PPPL NONCONFORMANCE REPORT NO: 3735    Open Date 11/15/07    Rev #: 1 , 12/20/2007

Status	1 - Eng Dept Head Concur Required	Trend	05-Design Interference
Department	NCSX	Division	WBS 142
Source/Org	Fabrication, Operations & Maintenance		
Item Dwg/Part#	b1_mtm_data_check.asm	Procurement #	WPF-1224
Cost Center	WBS/Other	00/00/00	
RAP#	3304	Job Doc #	WPF-1224
		Vendor	
RAP Title	Coil to Coil Assembly Trials

Review of “B1” to “C1” interface  
Response to NCR 3735  
and  
Deviation Request to Address  
Remaining B-C Coil Interfaces

"B" MC is shown along with B1 scan points

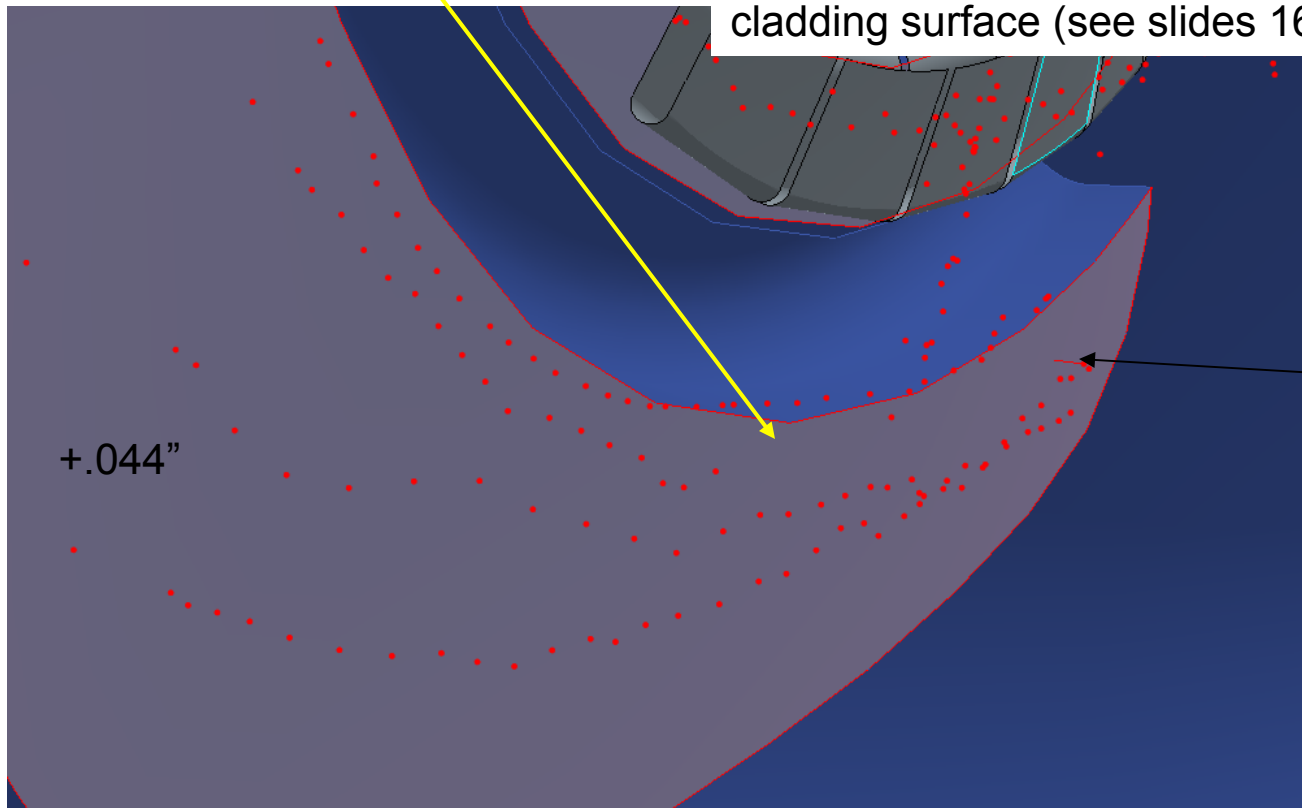
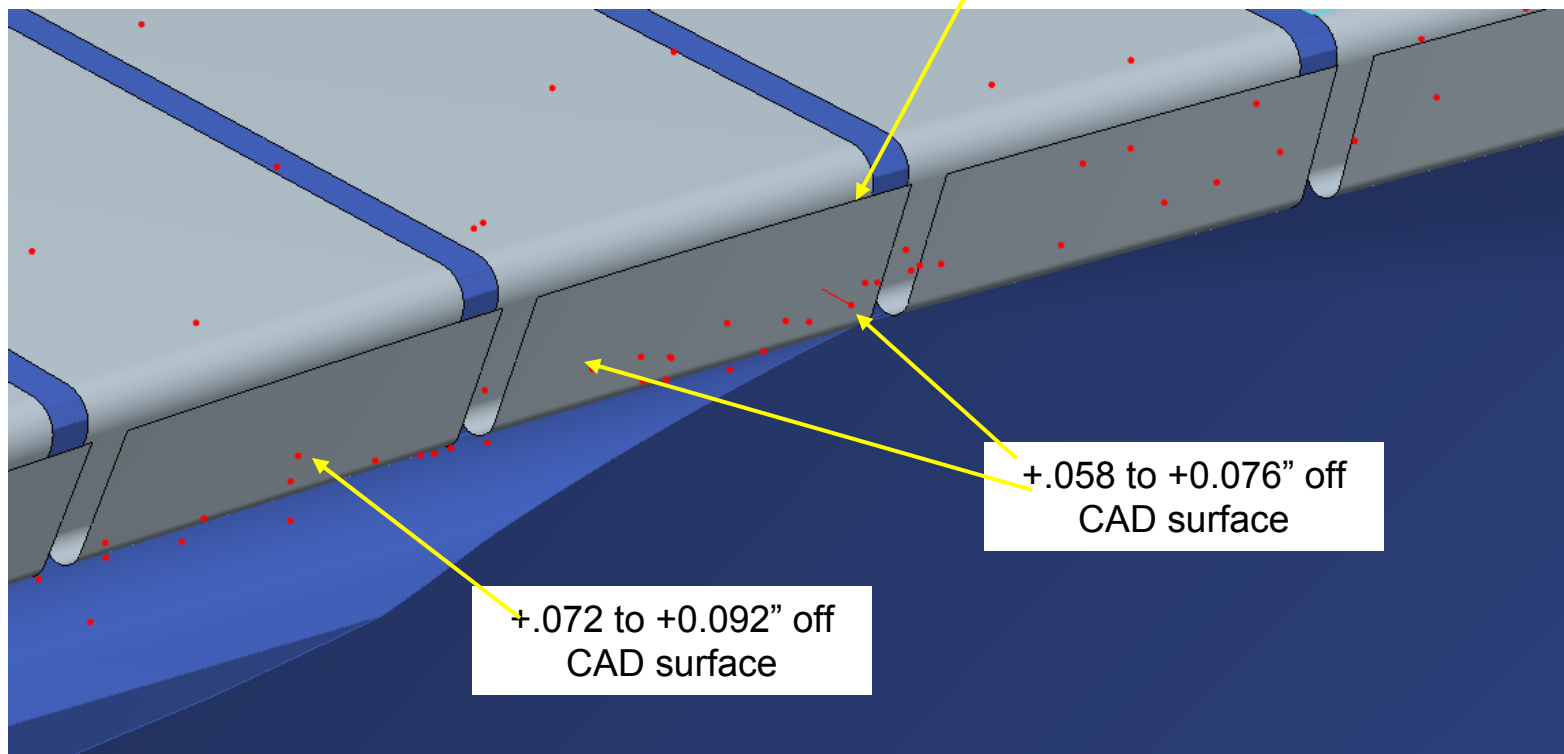
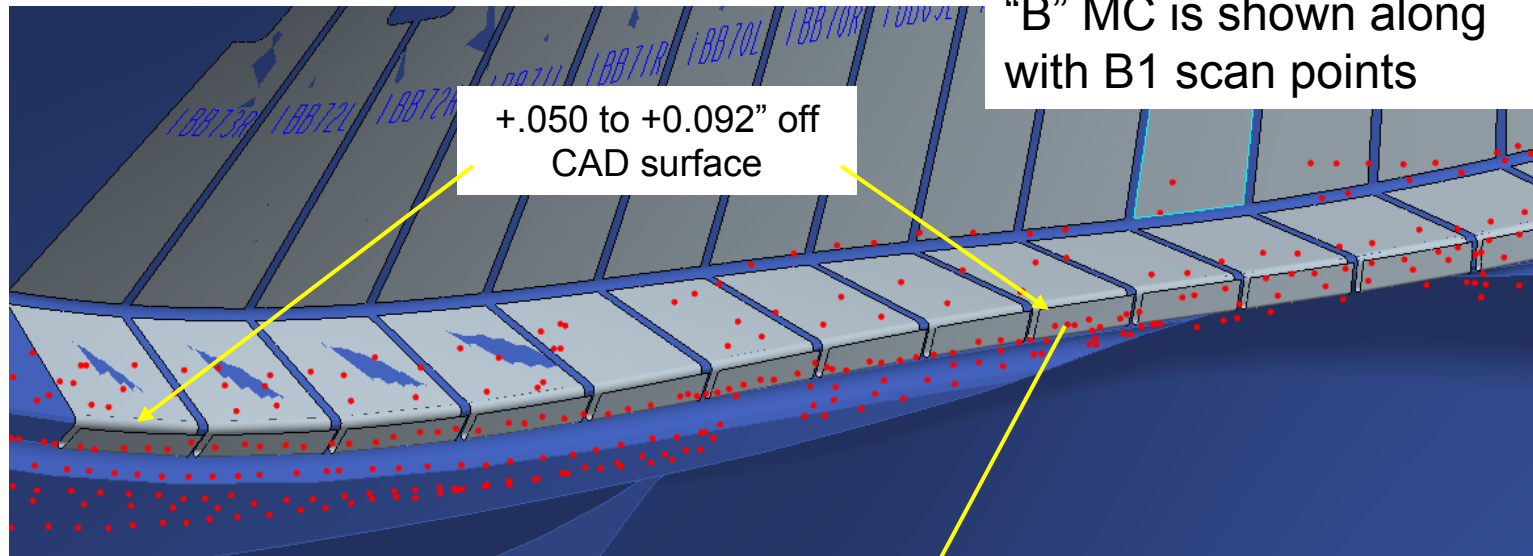
The new B1 scan data shows the surfaces are off the CAD model at a max condition on the order of +.058" and has a max value of +.092" off the cladding surface (see slides 16 and 17).
